Comment on Sustainability Strategy for the Enseigh South development on behalf of Transition Bath, a voluntary local sustainability organisation

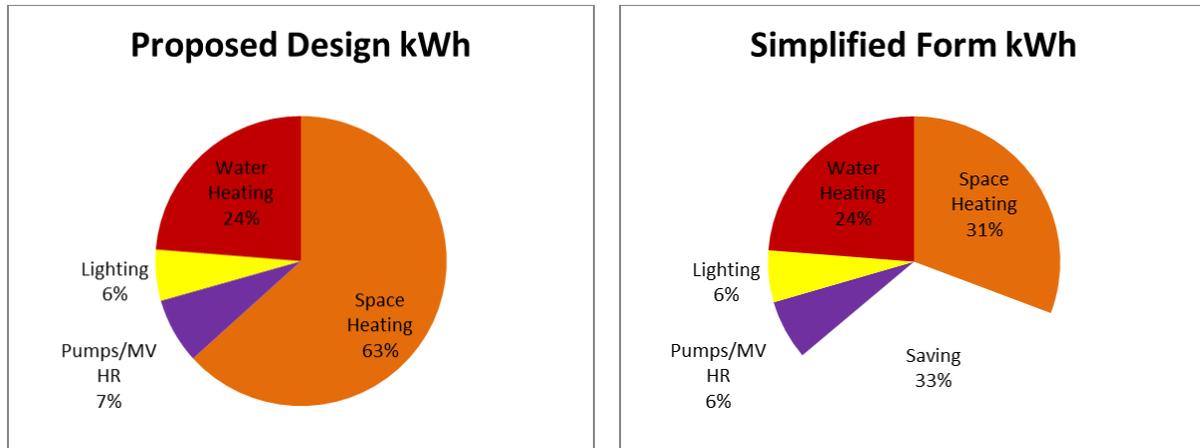
The proposed design uses 50% more energy than a simplified design but with a boxier and less fussy design of the same volume, floor area, number of floors and fabric– i.e a lower surface area to volume ratio. Modelling both the proposed design versus the simplified design using full SAP 2009 software gives the following result:

The simplified design halves the terraced houses' space heating requirements, and reduces the houses' energy consumption by 50% overall. Unfortunately this is a failing of the DER/TER methodology of CfSH which fails to recognise the benefits of simplified designs.
